Presentation to the Independent Planning Commission
Hills of Gold wind farm

Supporting material to my verbal presentation

NAD_22

Corner A

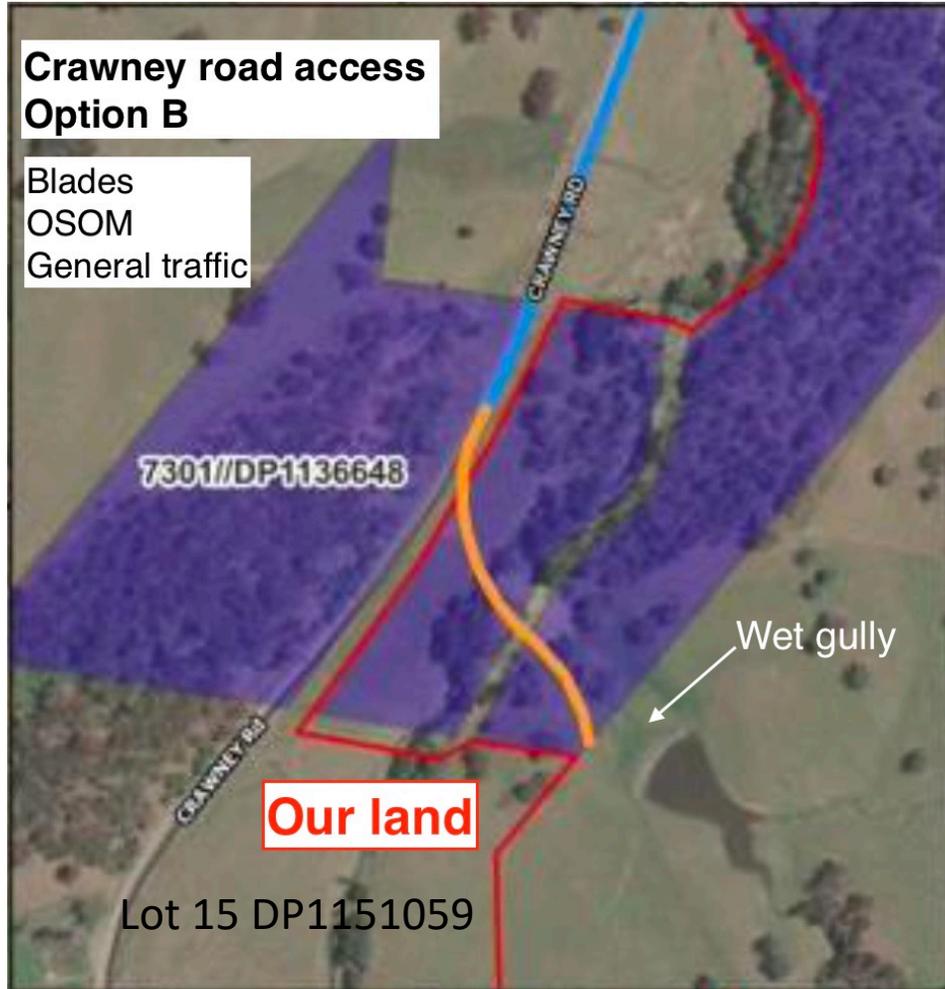
The location of the recommended access to wind farm site from Crawney Road (Option B) in relation to our private land

We would like it to be a condition of consent that the Applicant must survey the corner and install a fence for the length of 50 meters either side of the corner. This is to ensure that not an inch of our land is disturbed during the construction of the access option B, and enough soil is left on the corner for the fence to stand.

Corners B1 and B2

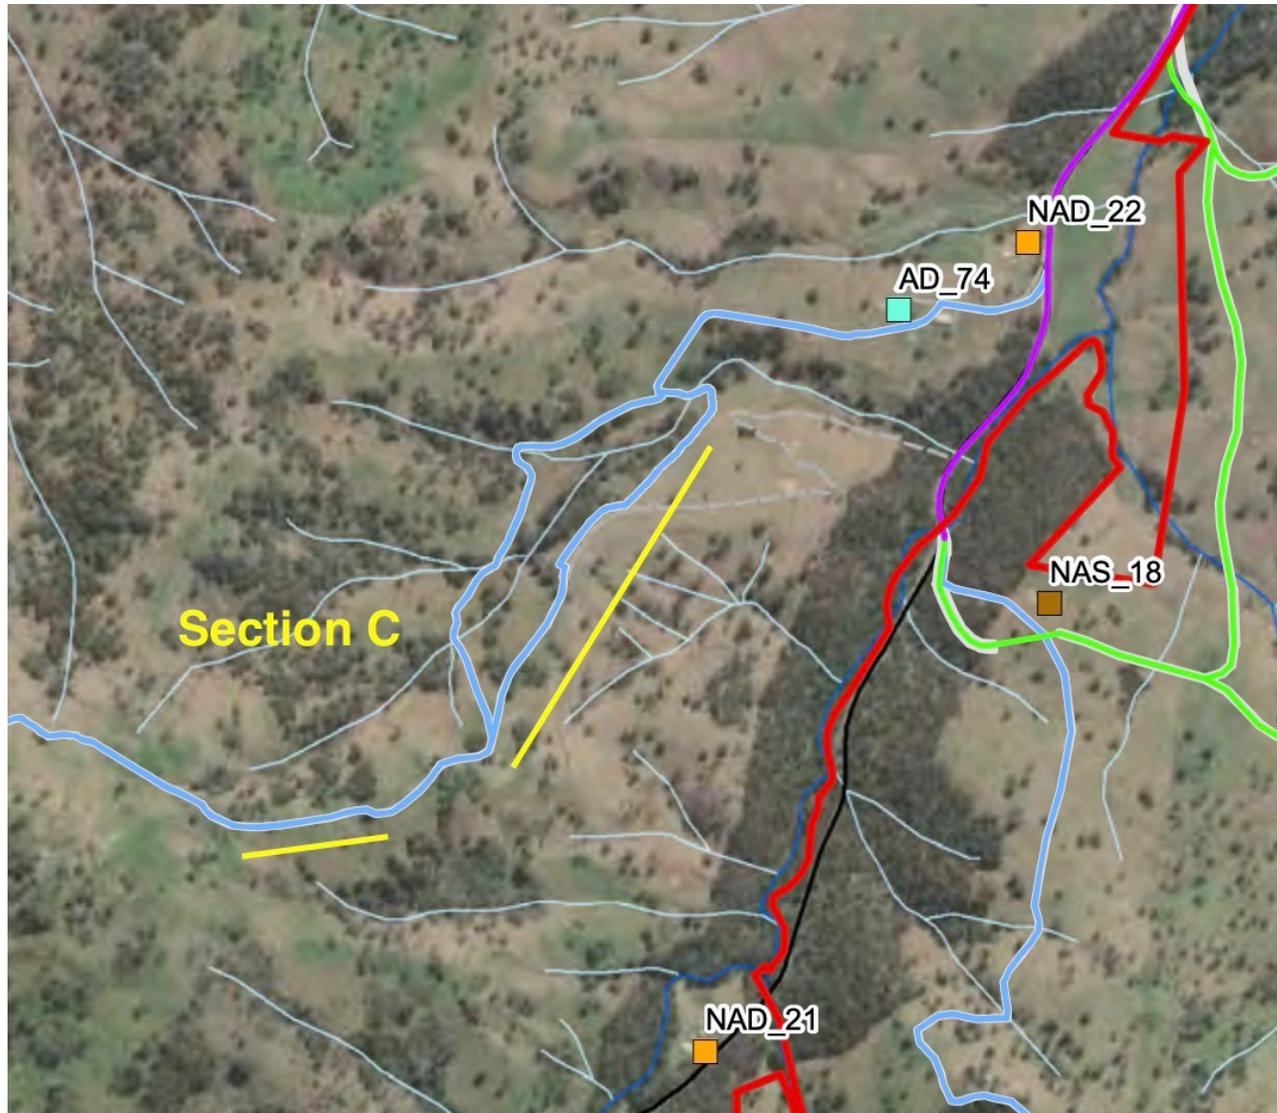
Access to powerline construction vehicles
Trucks with wire spools and tower sections
Electrical components
Gravel and cement tracks
All meters within our home

Conditions:

- Survey the corners
- Time of use/construction hours
- Dust suppression

Section C

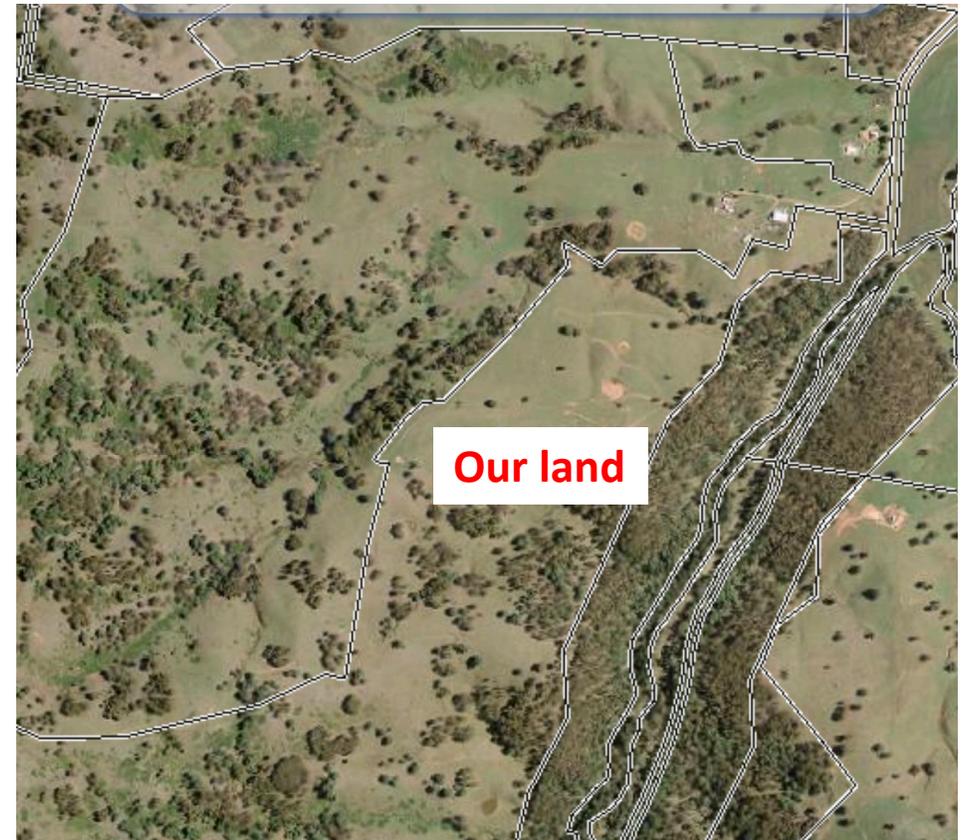
It appears that in some areas the power line construction access tracks are following our boundary very closely, or even trespassing.

Condition:

Survey the boundary

Figure B.1.1.2. Transmission Line (Option 1) Photomontage PM01 (Representative of AD_74)

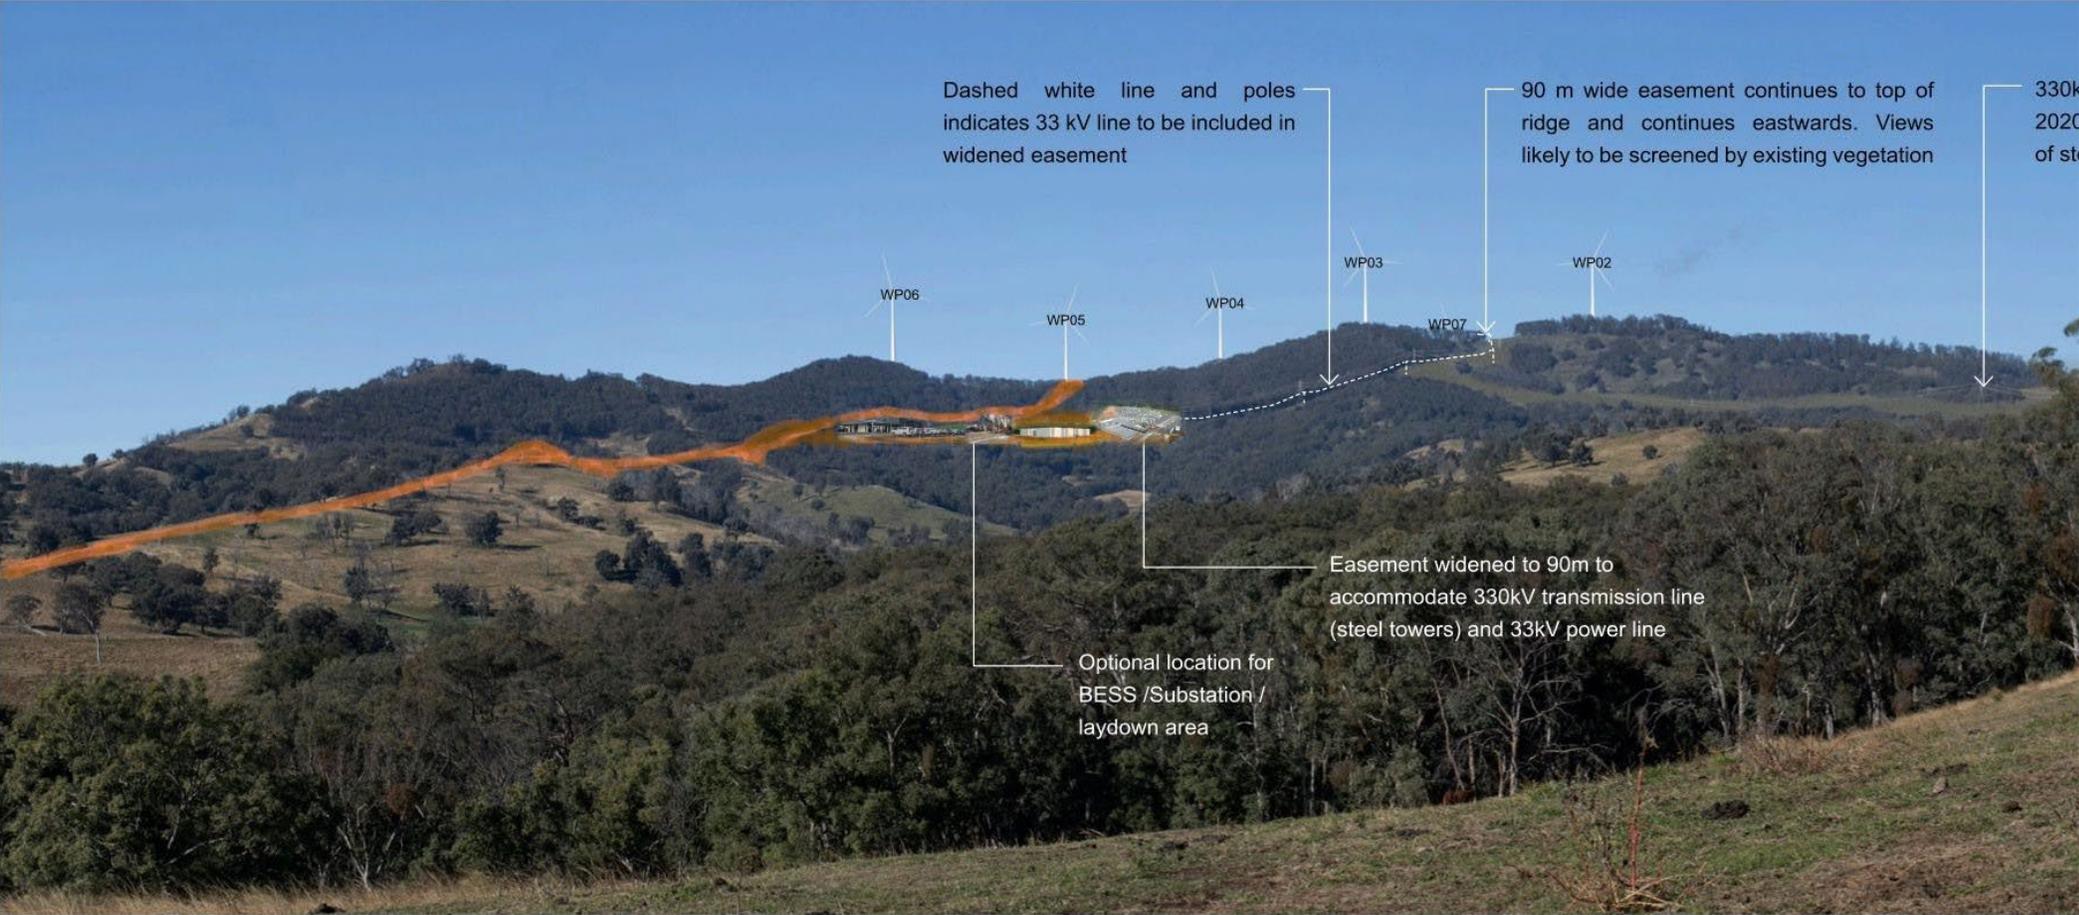
The Applicant has provided Photomontage PM01 to demonstrate the visual impact of the turbines and the power line corridor. They have **never** presented the visual impact of the Western access track to the development corridor (orange line) nor the big Battery bank, Concrete batching plant, Operations building and the Substation, all located on the shelf below turbine 5. A community member has added these element to the Applicant’s base picture to demonstrate the visual impact. **This is our visual impact.** This photomontage represents the view from the paddock next door, **200 meters from our house.**
